# Stage 04: Code Administrator Consultation

# GC0100 EU Connection Codes GB Implementation – Mod 1

This Code Administration Consultation contains the discussion and conclusions of the Workgroup which formed in July 2017 to develop and assess the proposal.

Figure 3.15(a) – GB Proposed Voltage Against Time Curve of a Type B Synchronous Power Generating Module showing the conflict with Stage 2 G59 Undervoltage Protection

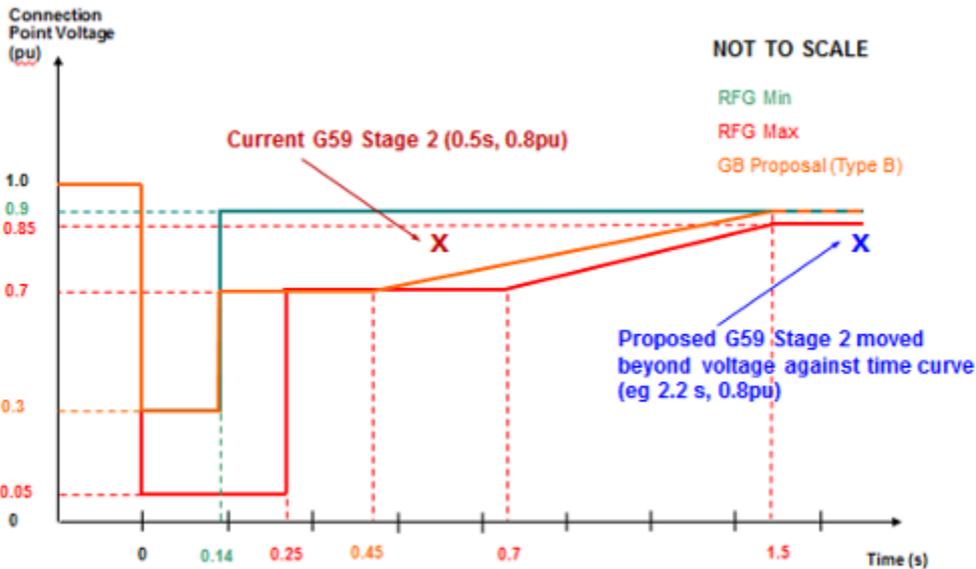
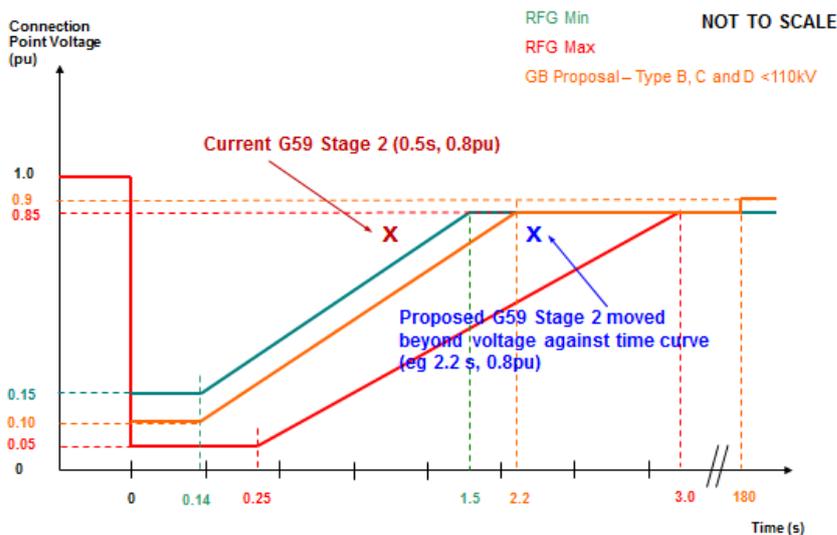
The proposed voltage against time curves for Type B – D Power Generating Modules are detailed above. For those Power Generating Modules which are connected to the Distribution Network, stakeholders noted that there would be a conflict with the G59 under voltage Stage 2 protection which is currently set at 0.8pu for 500ms. Whilst this was marginal in the case of the voltage against time curve for Synchronous Power Generating Modules it was more severe in the case of Power Park Modules where even the minimum RfG voltage against time criteria would have been incompatible with the current G59 Stage 2 under-voltage protection settings.

These issues are shown in Figures 3.15(a) and 3.15(b).

The Workgroup discussed this and The Proposer decided that the best policy for their original solution would be to move the G59 Stage 2 undervoltage protection to 0.8pu at 2.5s. This requirement would apply to all new connecting plant and would be equally applicable to Synchronous Power Generating Modules and Power Park Modules.

It was not believed that changing the G59 Stage 2 Undervoltage protection would cause a significant problem however it was included as a consultation question. The Grid Code/Distribution Code workgroups GC0035 and GC0079 continue to investigate the issues associated with changing RoCoF protection settings for distribution connected generators and have undertaken a risk assessment of Distribution system protection requirements. The analysis for this has been performed by the University of Strathclyde.

The University of Strathclyde were asked to comment on whether the proposed change to a single undervoltage protection would introduce any new risks. Their analysis pointed out that as the RfG only applies to new installations, it does not affect the risk profile for existing plant.

Figure 4.5 – Proposed Voltage against time curve for Title II HVDC Converters

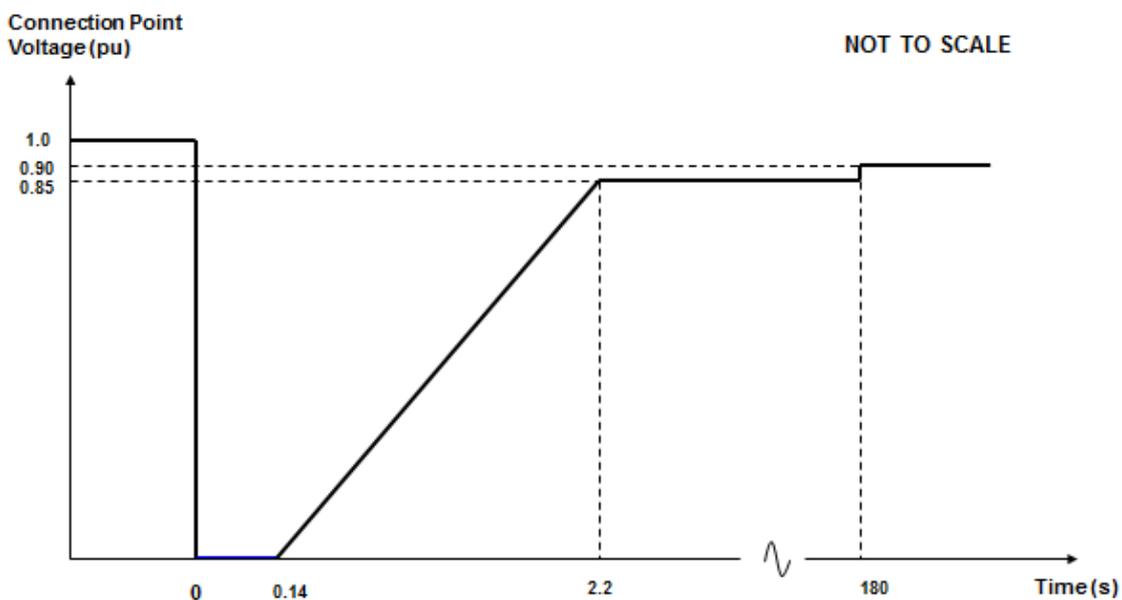
<i>Athanasios Krontiris &amp; Grant McKay, ABB HVDC</i>	The fault ride through curve for HVDC converters in Figure 7.3 is in accordance with the EU network code. However, the fault ride through is not related to fault current injection. Setting Ublock equal to zero practically disqualifies line-commutated converters. During drafting of the EU network code for HVDC, great care was taken to avoid such general disqualifications and we suggest that this may be reconsidered. We would like to further highlight that the instance of fault clearance needs a clear definition. The requirements for FRT and subsequent active power recovery up to 90% within 500 ms from fault clearance must be related to the instance the voltage returns in the 0.9-1.1 pu band. Otherwise significant overrating of the converter is necessary. Note that the term "fault clearance" is also used in Figures 4.4 and in section 4.4, however with another interpretation.
